## **ADDENDUM 4**

<u>SUBJECT</u>: Sidney Brooks (City Base Land – S New Braunfels) 2022 Bond, (ID No.: 23-03916)

# THIS NOTICE SHALL SERVE AS ADDENDUM NO. IV - TO THE ABOVE REFERENCED INVITATION FOR BIDS

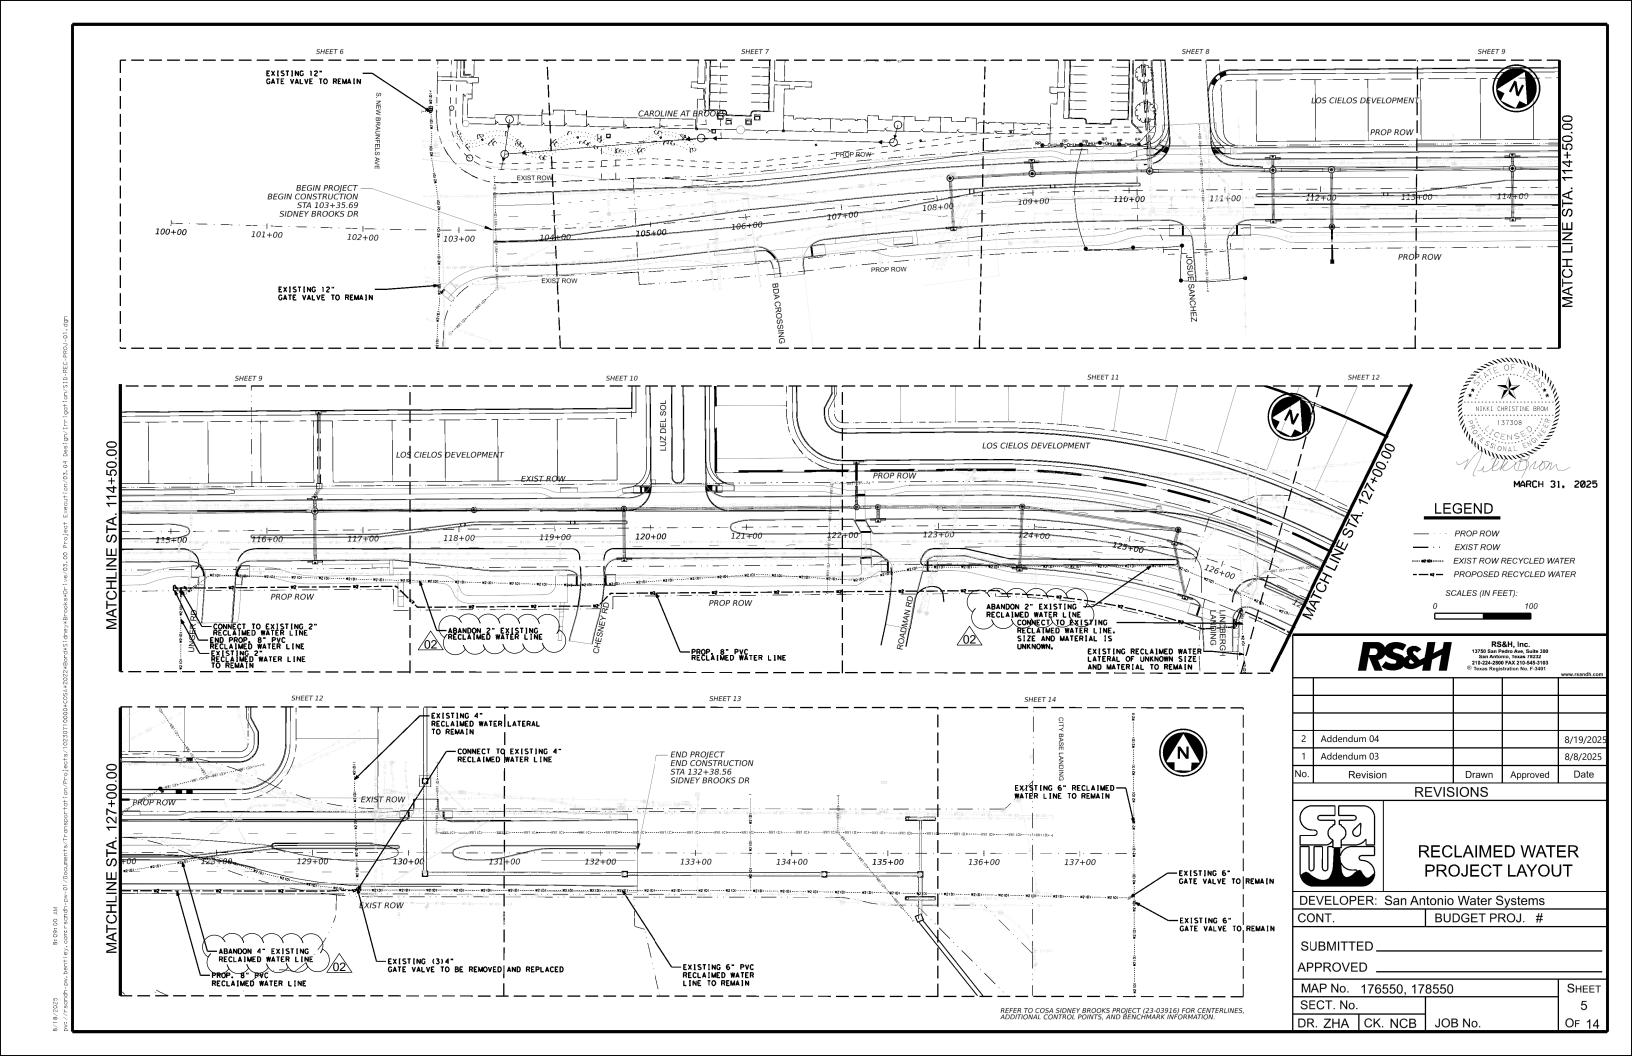
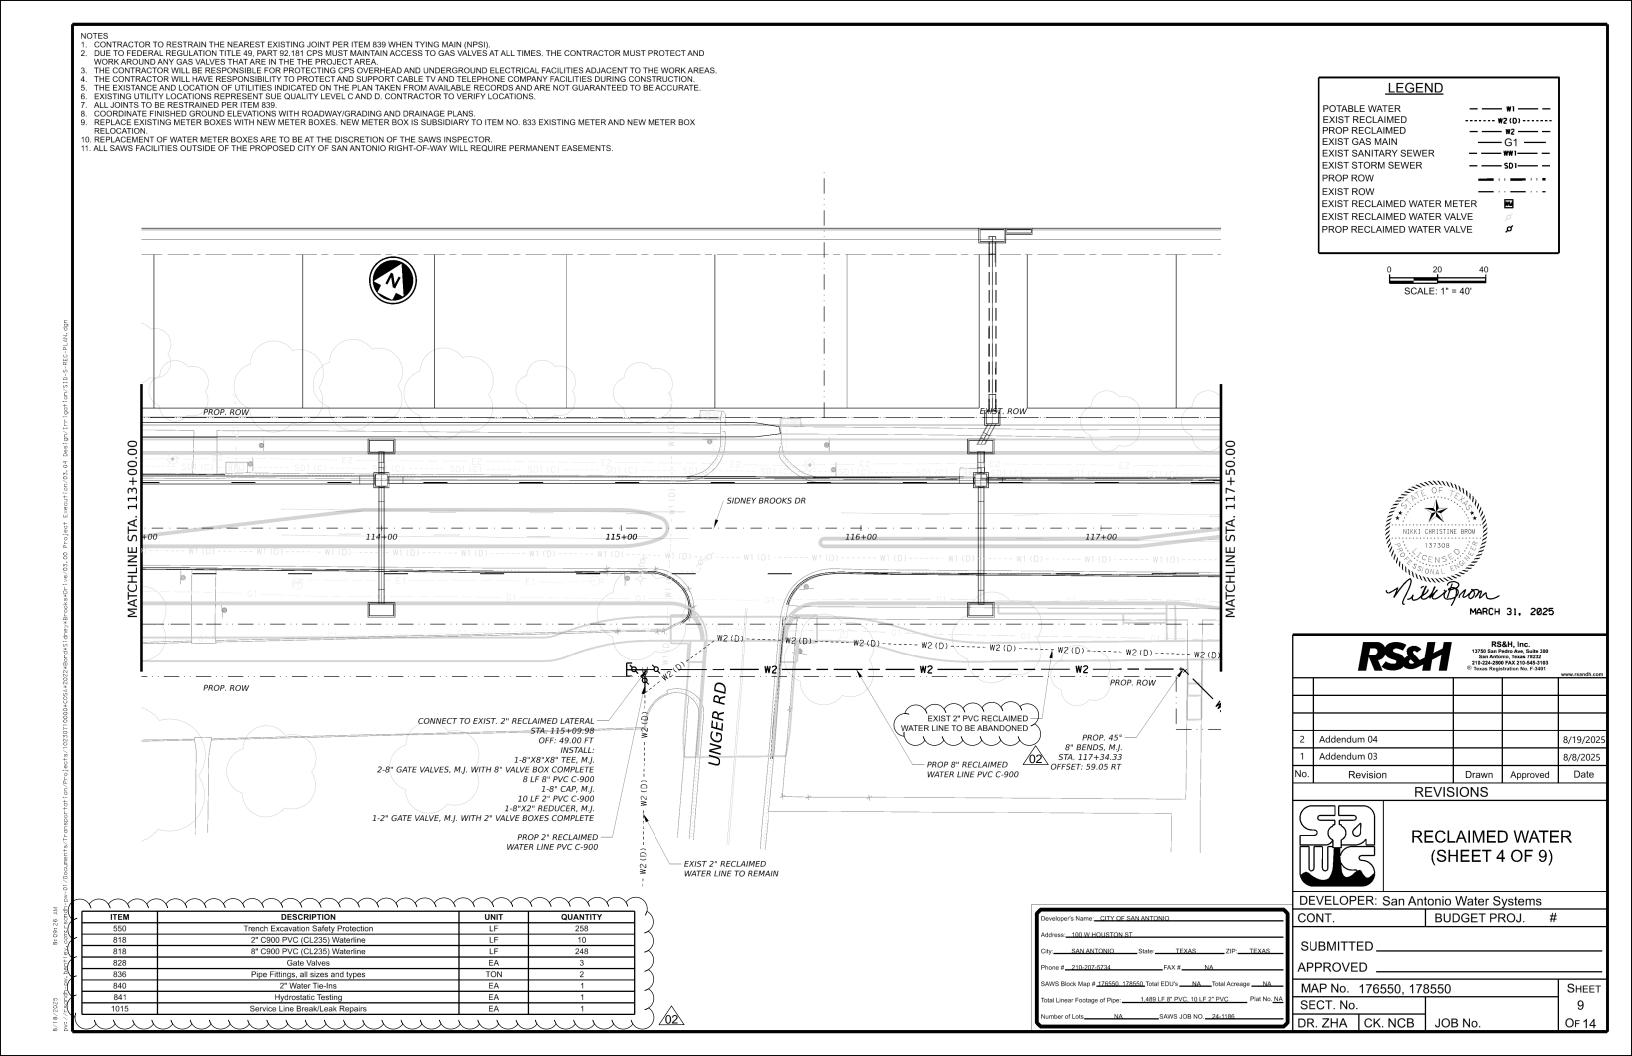
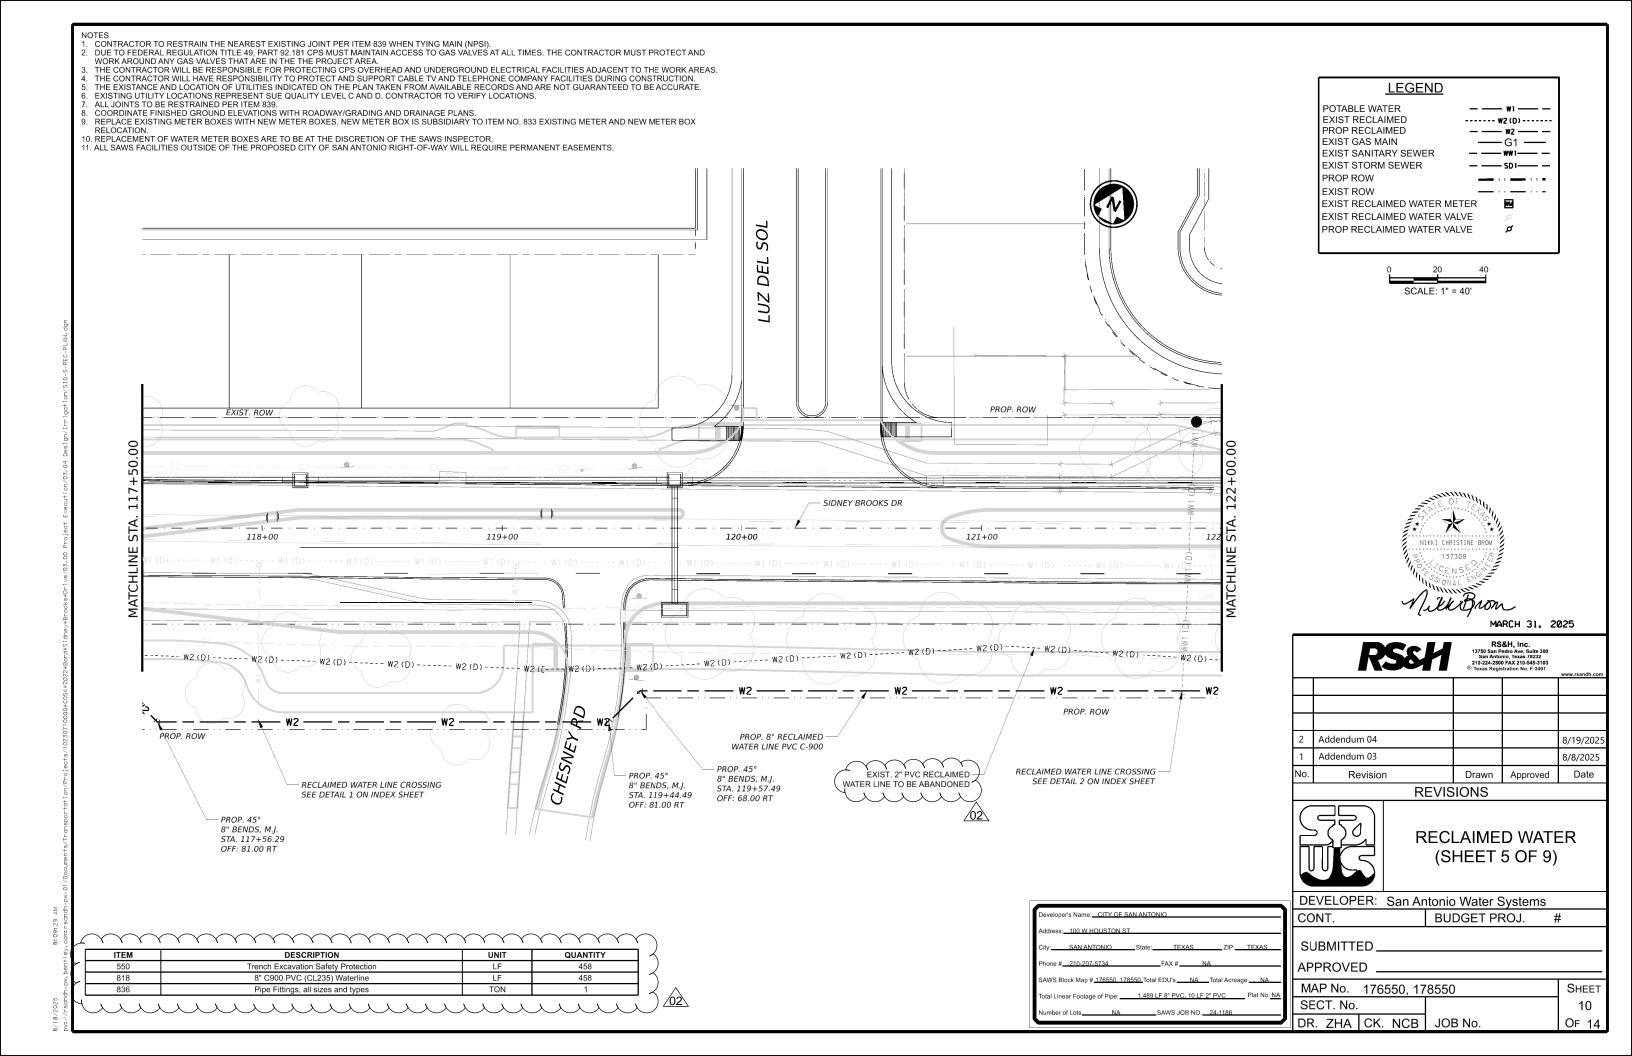
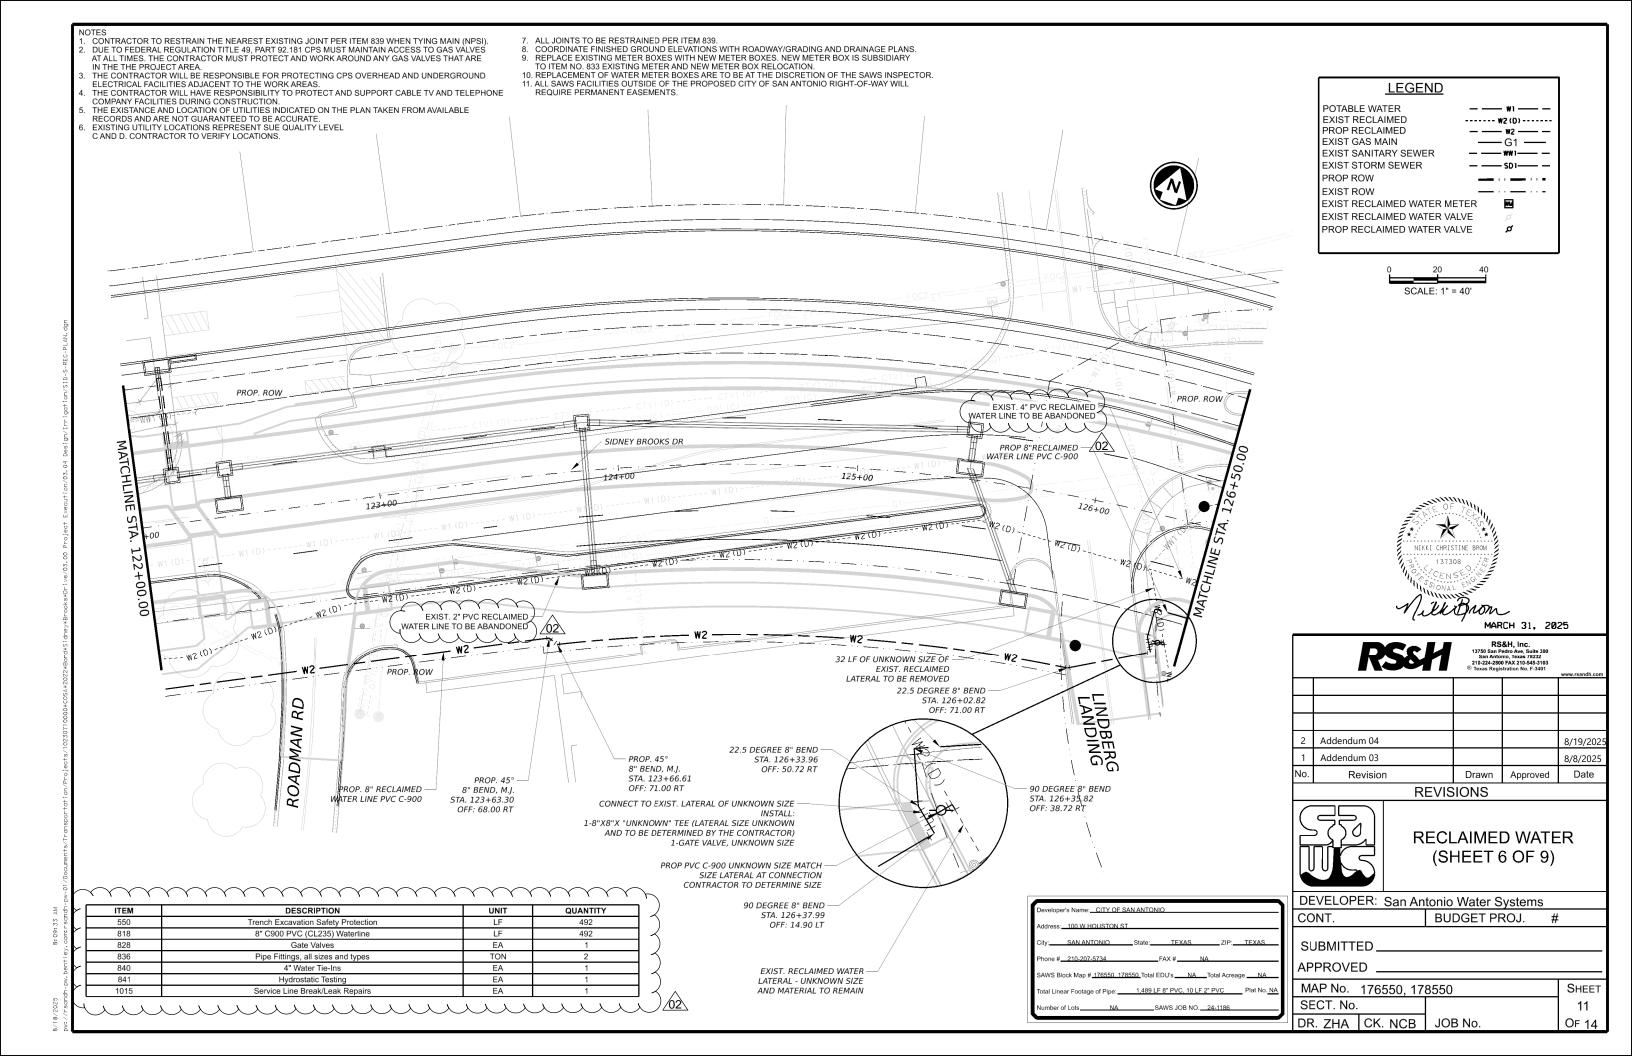
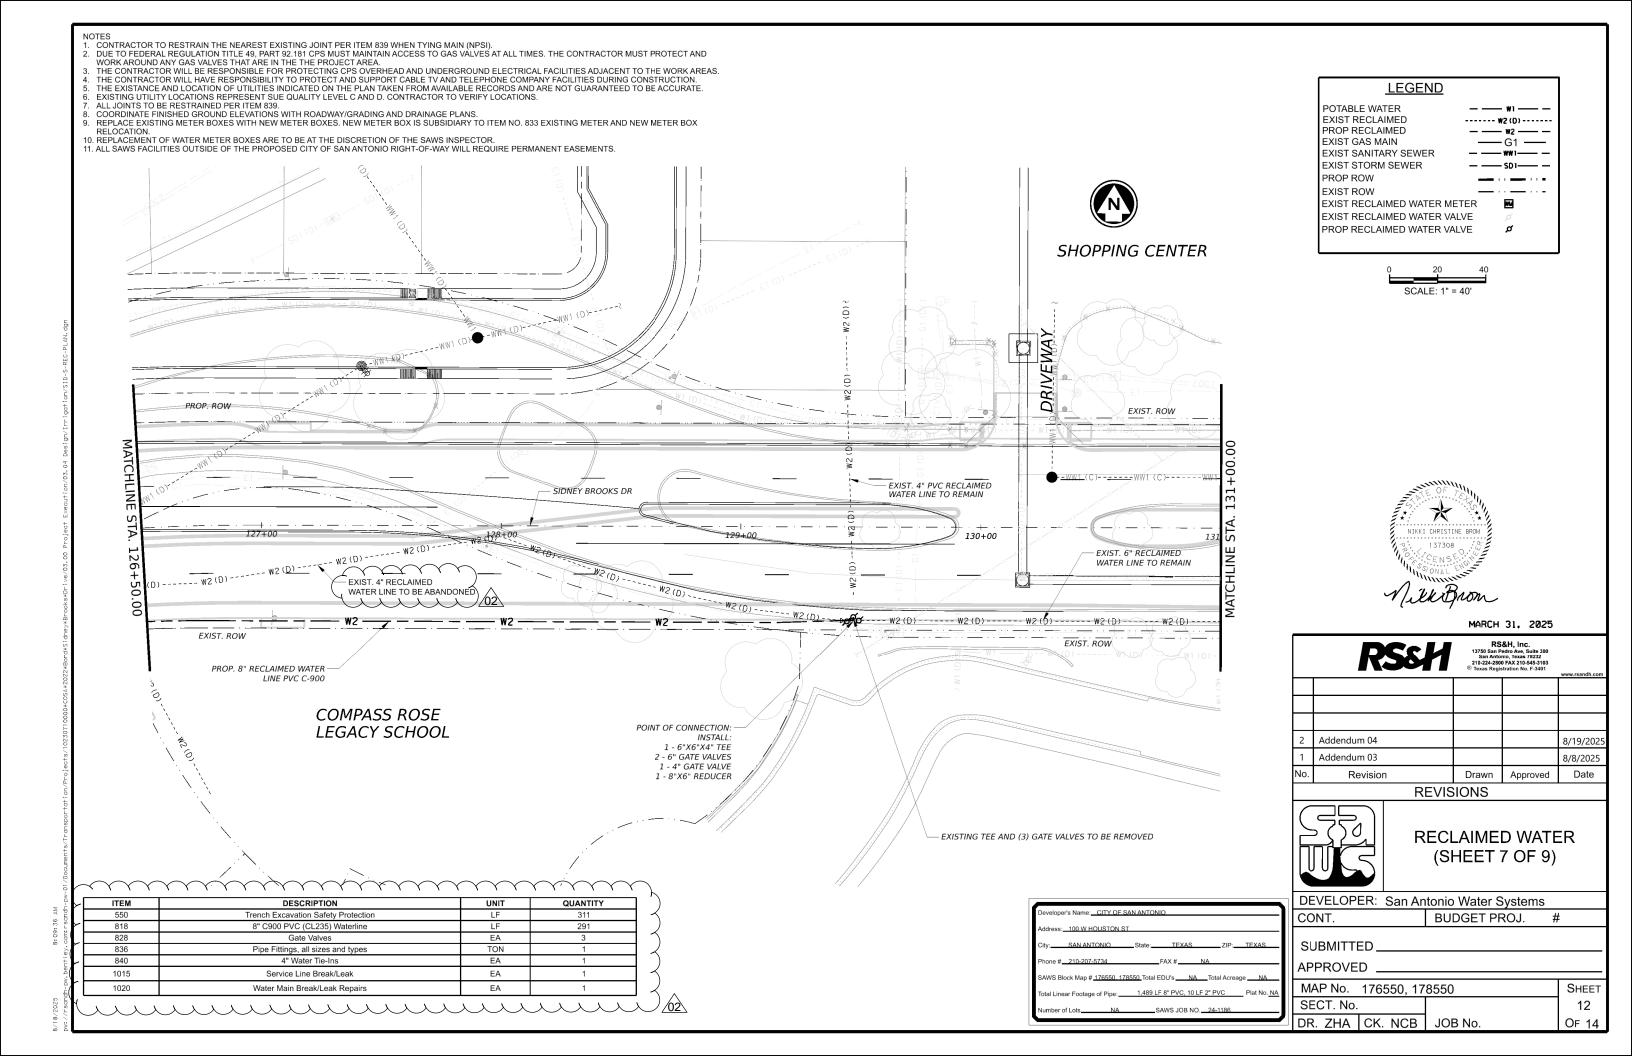
- a. Renumbered notes due to inclusion of Note 21.
- 4. Sheet 296 SAWS Reclaimed Water Project Layout:
  - a. Revised callouts stating "Remove" to state "Abandon" instead.

- 5. Sheet 300 SAWS Reclaimed Water Plan Sheet 4:
  - a. Revised Quantity Box Removing Item 7023-7023 REMOVING EXISTING WATER LINE (2 IN) 250 LF
  - b. Revised callouts stating "Remove" to state "Abandon" instead.

- 6. Sheet 301 SAWS Reclaimed Water Plan Sheet 5:
  - a. Revised Quantity Box Removing Item 7023-7023 REMOVING EXISTING WATER LINE (2 IN) – 451 LF
  - b. Revised callouts stating "Remove" to state "Abandon" instead.

- 7. Sheet 302 SAWS Reclaimed Water Plan Sheet 6:
  - a. Revised Quantity Box Removing Item 7023-7023 REMOVING EXISTING WATER LINE
     (2 IN) 347 LF
  - b. Revised Quantity Box Removing Item 7023-XXXX REMOVE EXISTING WATER LINE (4 IN) 95 LF

- c. Revised callouts stating "Remove" to state "Abandon" instead.
- 8. Sheet 303 SAWS Reclaimed Water Plan Sheet 7:
  - a. Revised Quantity Box Removing Item 7023-XXXX REMOVE EXISTING WATER LINE (4 IN) – 133 LF

- b. Revised callouts stating "Remove" to state "Abandon" instead.
- 9. Sheet 328 CPS Gas Plans Title Sheet 1:
  - a. Revised CPS GAS Item 1014026 PIPE PLASTIC 6" IPS SDR 11 WITH TRACER WIRE – 2401 LF TO 2547 LF
